UNITED STATES
NUCLEAR REGULATORY COMMISSION
WASHINGTON, D. C. 20555

NOTE TO: Margaret Federline
FROM: Joseph Holonich
SUBJECT: OFFICE OF RESEARCH PROGRAM PLAN

Attached is the HLPD review of the first two chapters of the Office of Research Program Plan. HLPD has coordinated this review with HLHP (Rex Wescott) and HLGE (Ron Ballard) as well as with Mel Silberberg.

Figure 2: RESEARCH PROGRAM - REGULATORY PROGRAM INTEGRATION

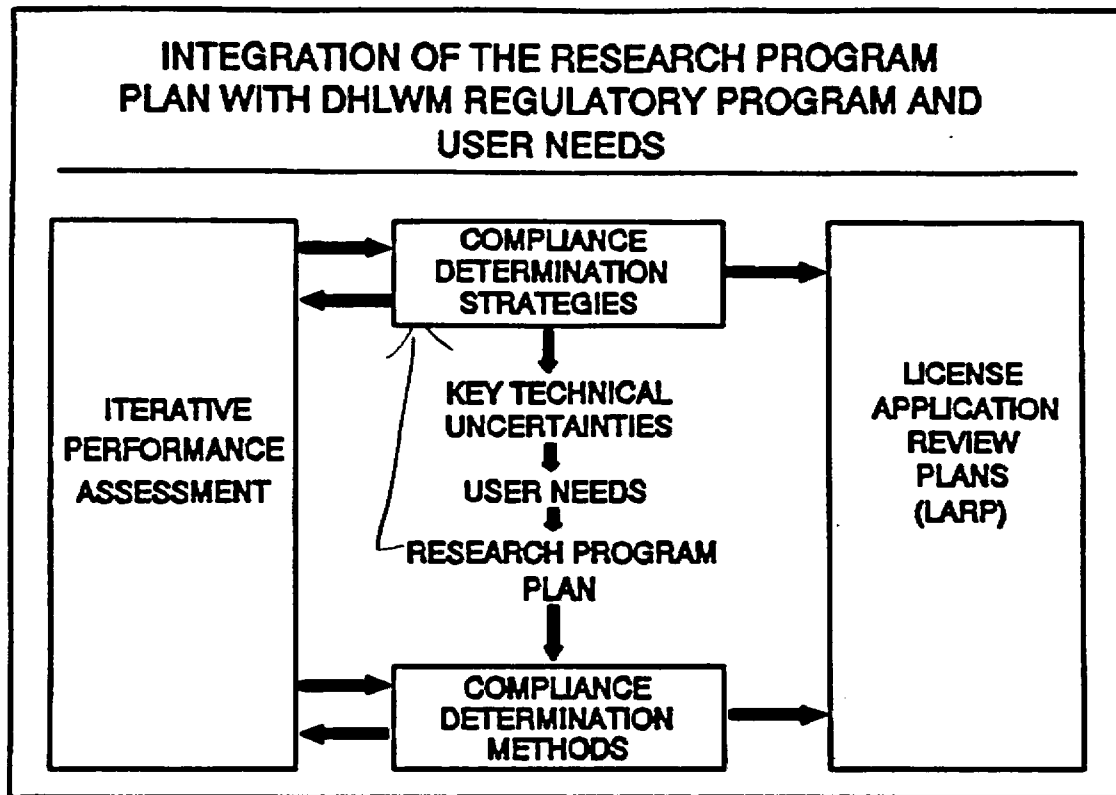
In figure
Change to review strategy
CDS to review method and
CDR to review acceptance criteria

Review
method and
Acceptance
Criteria

~~IRA influences and is influenced by CDS and CDM development. IPA contributes to the identification and refinement of specific technical uncertainties. IPA provides an assessment of importance/priority of uncertainties by means of sensitivity analyses and focuses on the impacts of performance.~~

~~LARP CDS and CDM development is iterating based on results of IPA and evaluation of the research program results. CDS development is scheduled for initial completion of FY 93 and CDM development is scheduled for completion during FY 94-97. These products and processes all influence each other and are designed for iteration and refinements.~~
